## Product Change Notification: SYST-01SSSS214

PIC16(L)F1934/1936/1937 Family Silicon Errata and Data Sheet Clarifications

Updated the document format to the current Microchip publication standard; module numbers under silicon errata have been renumbered accordingly.

Added silicon issue 1.6.3; added data sheet clarification 2.1.

**Figure 1-1.** Instruction Cycle Delay Calculation Example

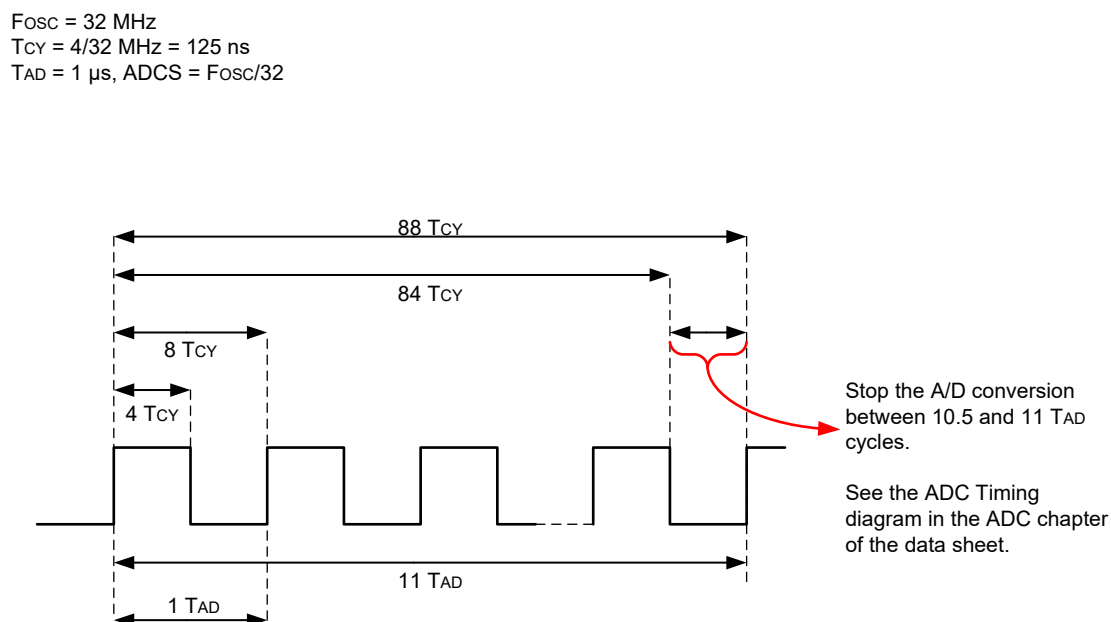
This method is provided if the application cannot use Sleep mode and requires continuous operation at frequencies above 8 MHz. This method requires early termination of an ADC conversion. Provide a fixed time delay in software to stop the ADC conversion manually, after all 10 bits are converted, but before the conversion would complete automatically. The conversion is stopped by clearing the GO/DONE bit in software, and must be cleared during the last  $\frac{1}{2} T_{AD}$  cycle, before the conversion would have completed automatically.

In [Figure 1-1](#), 88 instruction cycles will be required to complete the full conversion. Each  $T_{AD}$  cycle consists of 8  $T_{CY}$  periods. A fixed delay is provided to stop the A/D conversion after 86 instruction cycles and terminate the conversion at the correct time.

**Note:** The exact delay time will depend on the  $T_{AD}$  divisor (ADCS) selection. The  $T_{CY}$  counts shown in [Figure 1-1](#) apply to this example only. Refer to [Table 1-1](#) for examples of the required delay counts for other configurations.

Select the system clock,  $F_{OSC}$ , as the ADC clock source and reduce the  $F_{OSC}$  frequency to 8 MHz or less when performing ADC conversions.

Select the dedicated ADCRC oscillator as the ADC conversion clock source and perform all conversions with the device in Sleep.
